**Proposed Subdivision**

**APPLICATION FOR SUBDIVISION PERMIT - SA 2020/00029, 5 Sunnyview Place, Honeywood**

PROJECT  
**5 SUNNYVIEW PLACE,  
HONEYWOOD  
SUBDIVISION**

# **BUSHFIRE HAZARD REPORT**

### **Subdivision Plans**

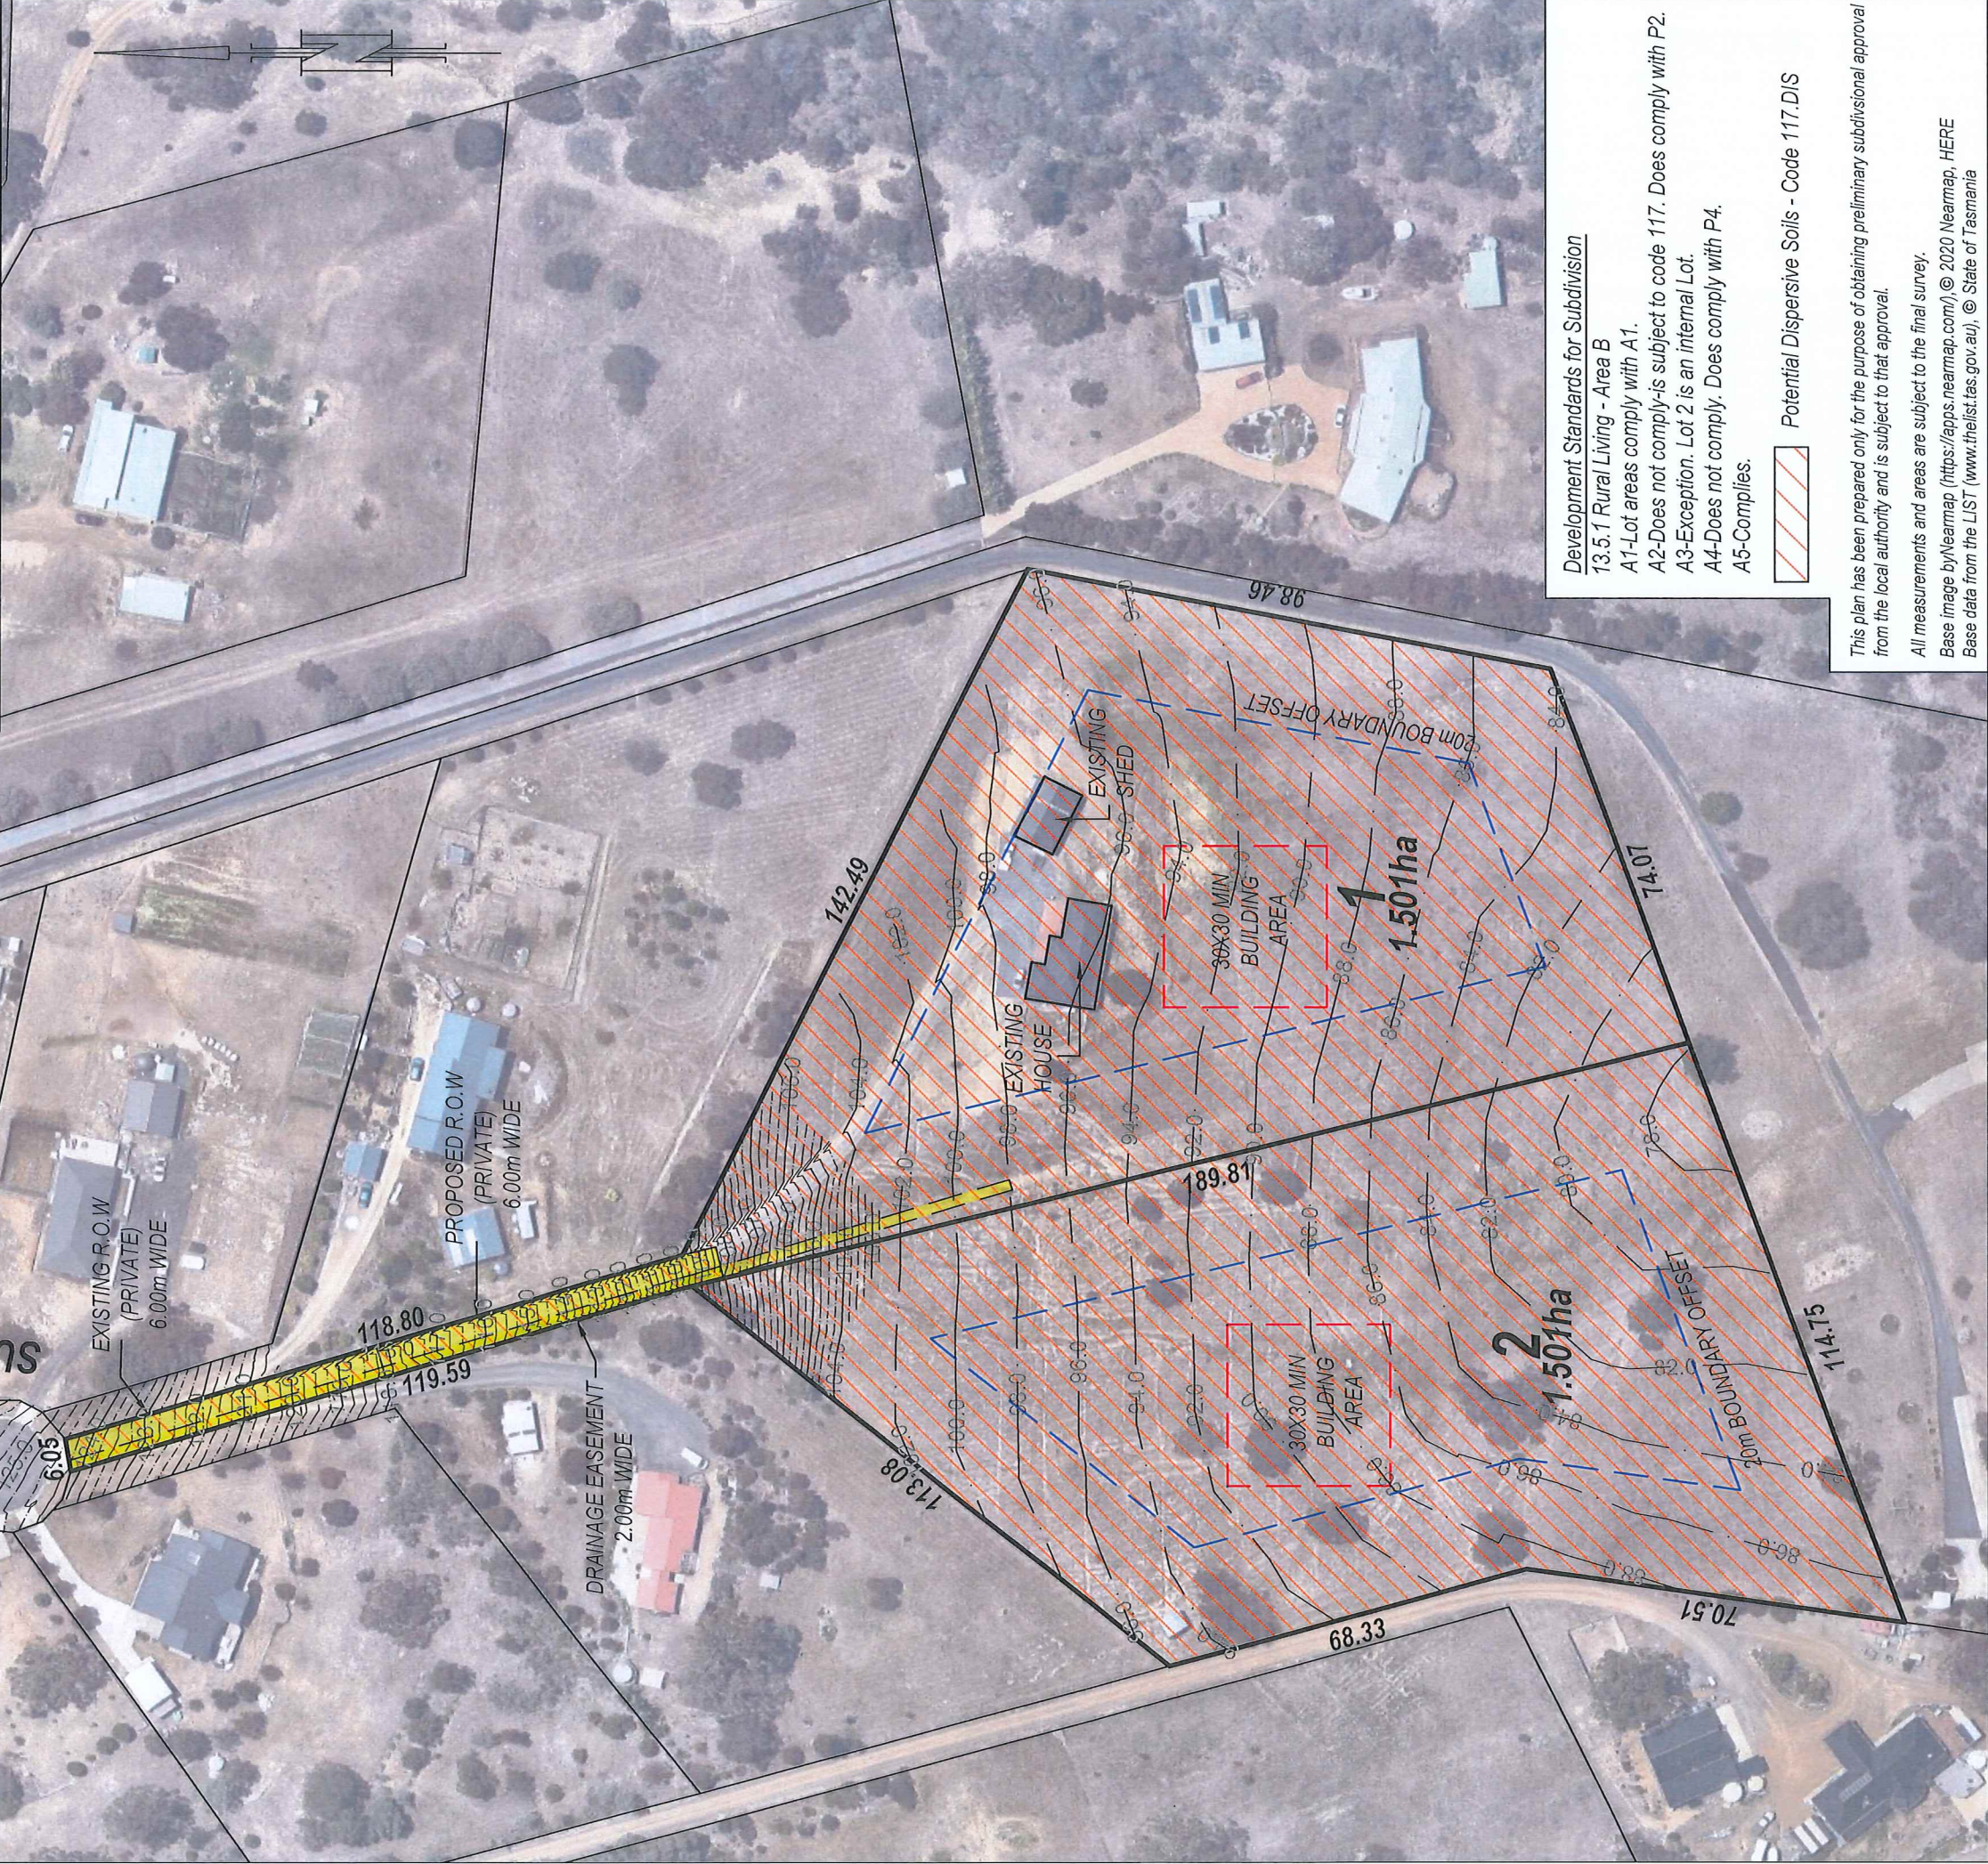
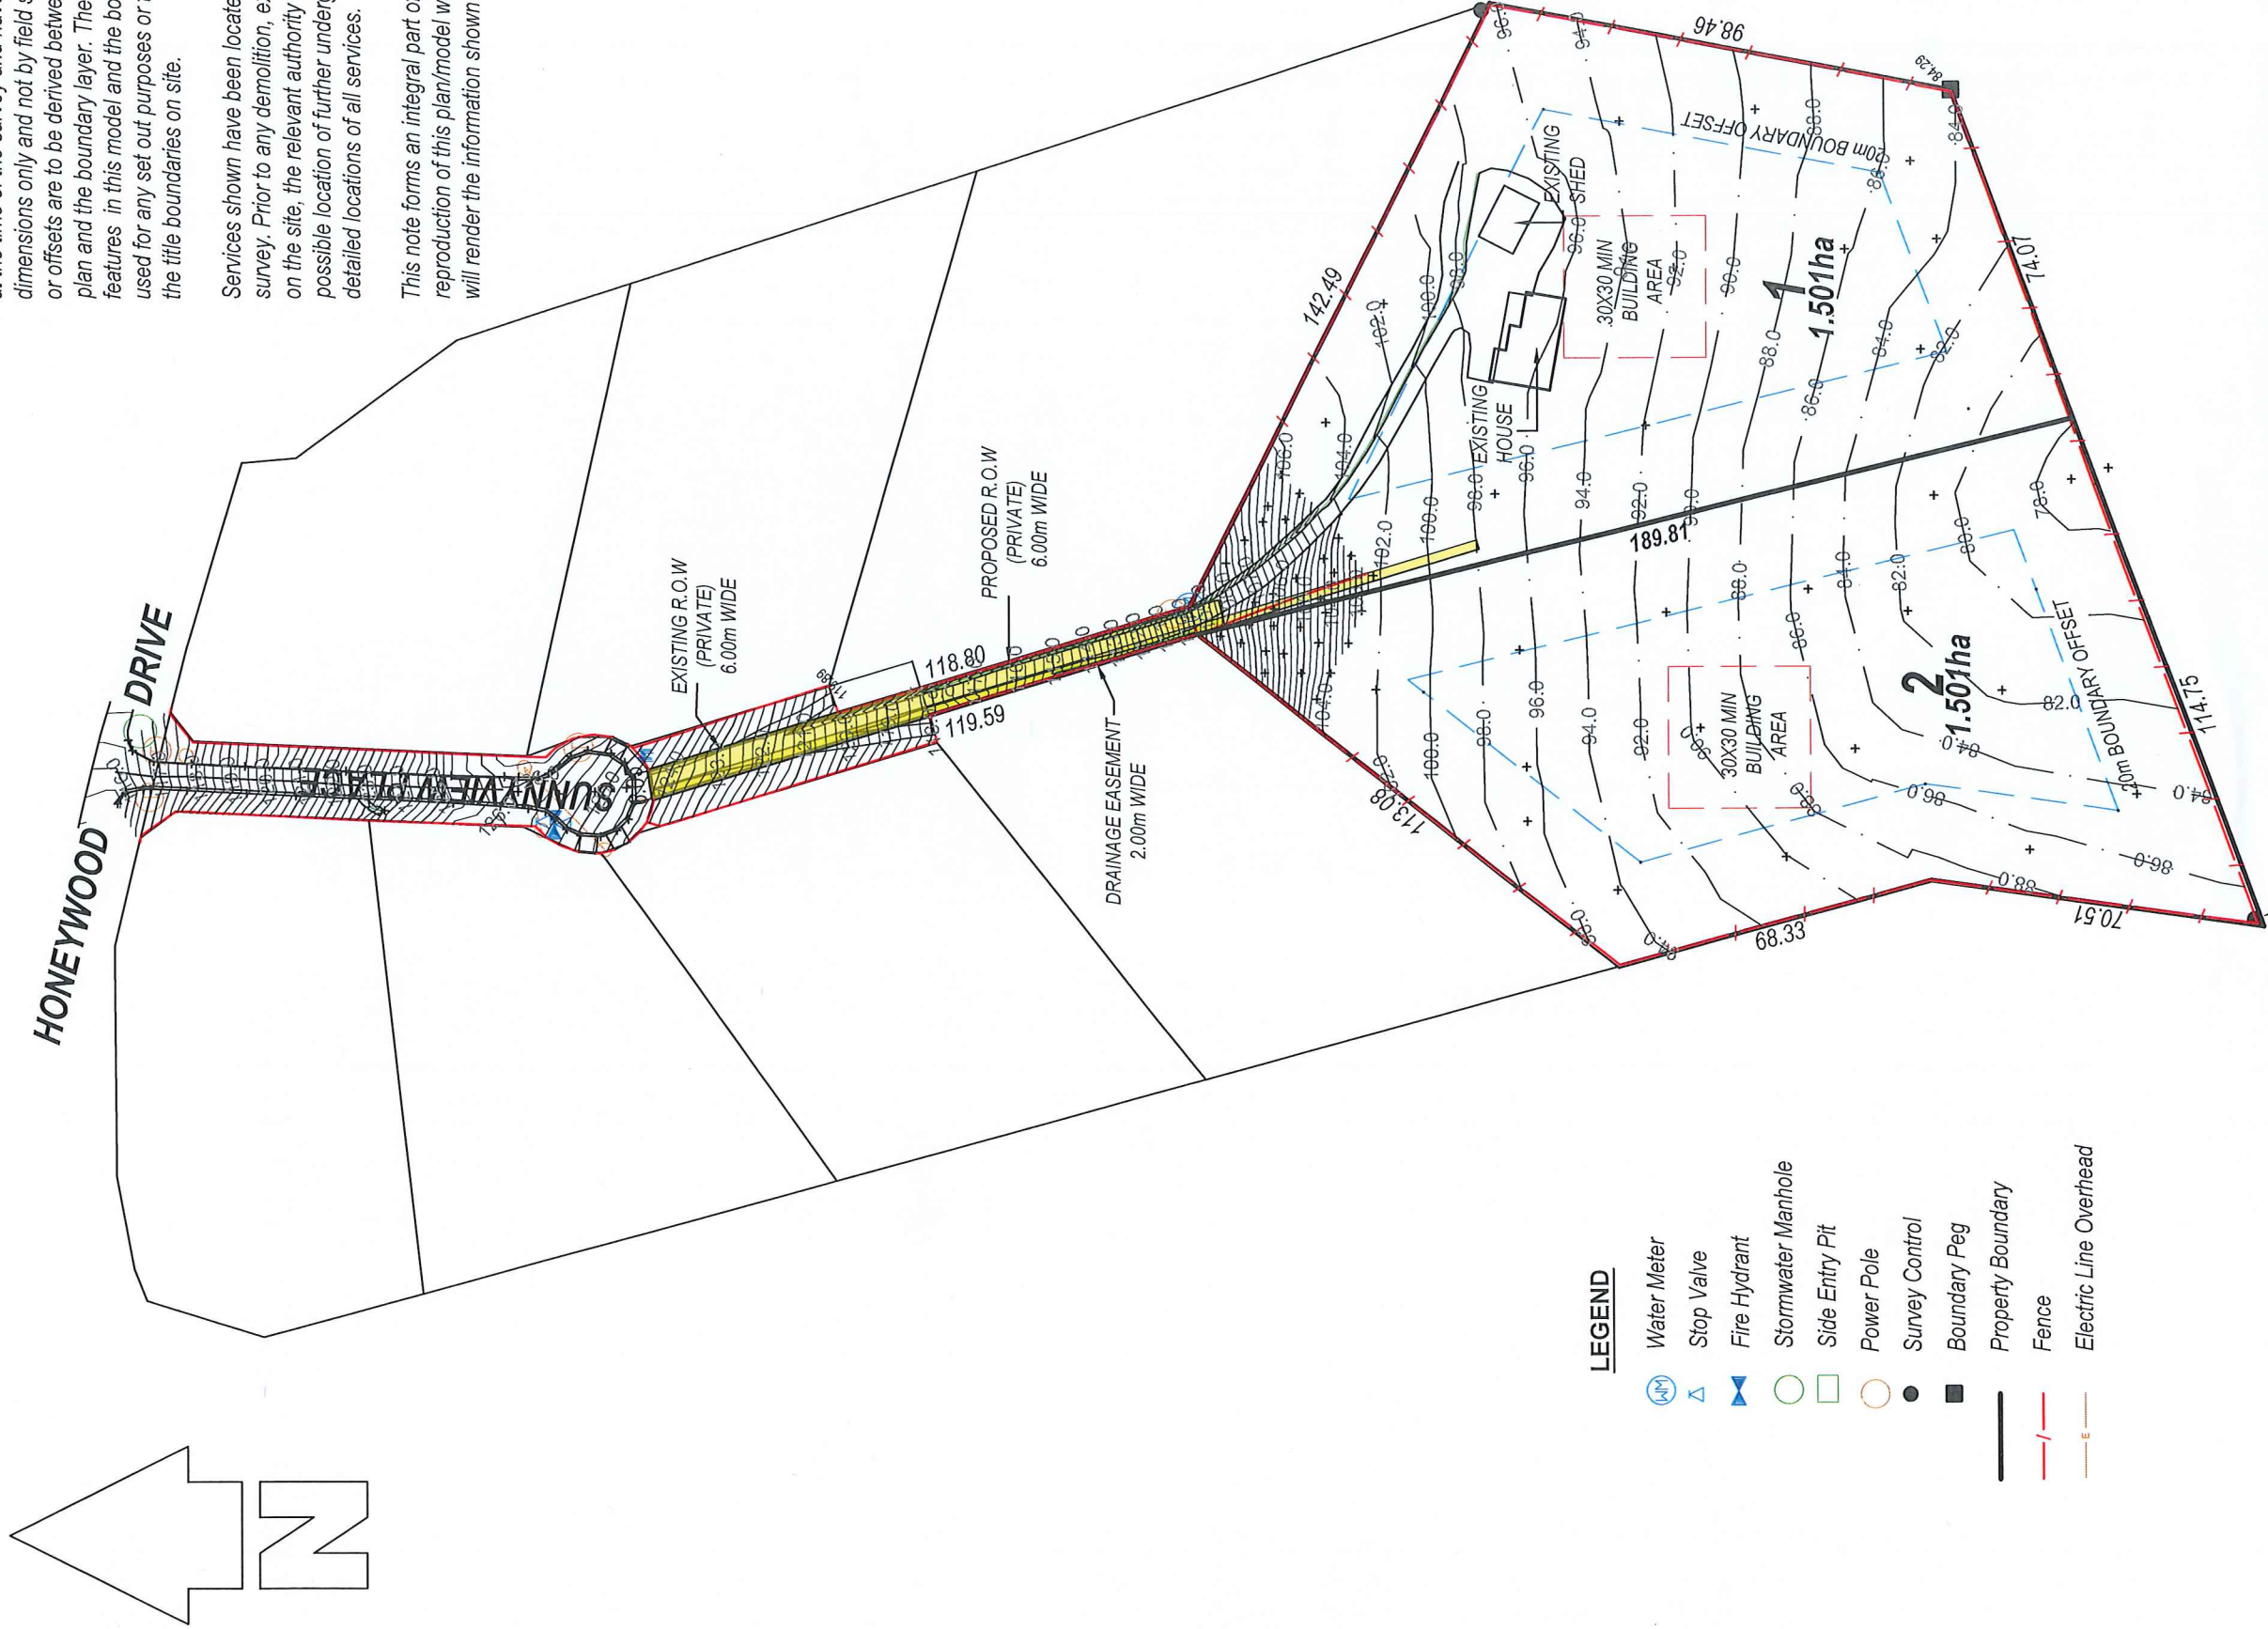
- Within the proposed subdivision, lot 1 will have an access strip 6m wide and lot 2 will have a 6m wide Right of Way over lot 1's 6m wide access strip, as shown on the subdivision plans in Attachment B. This arrangement satisfies sub-clause (f); As the width of the access strip is 119m long, it has been considered against *Clause E6.7.3 'Vehicular Passing Areas Along an Access'* within the Development Standards of the Parking and Access Code. As the access strip width is 6m, it exceeds the minimum width requirement of 5.5m specified in the Clause. Furthermore, it will not require passing areas and the maximum interval requirements (of no more than 30 m along the access) are not applicable as the entirety of the access strip width is 6m. Sub-clause (g) is therefore considered to be satisfied;

- The 'lots' access strip is combined with no more than 3 others, satisfying sub-clause (h);
- A sealed driveway is provided on the access strip as shown on the updated subdivision plan attached in Attachment B;
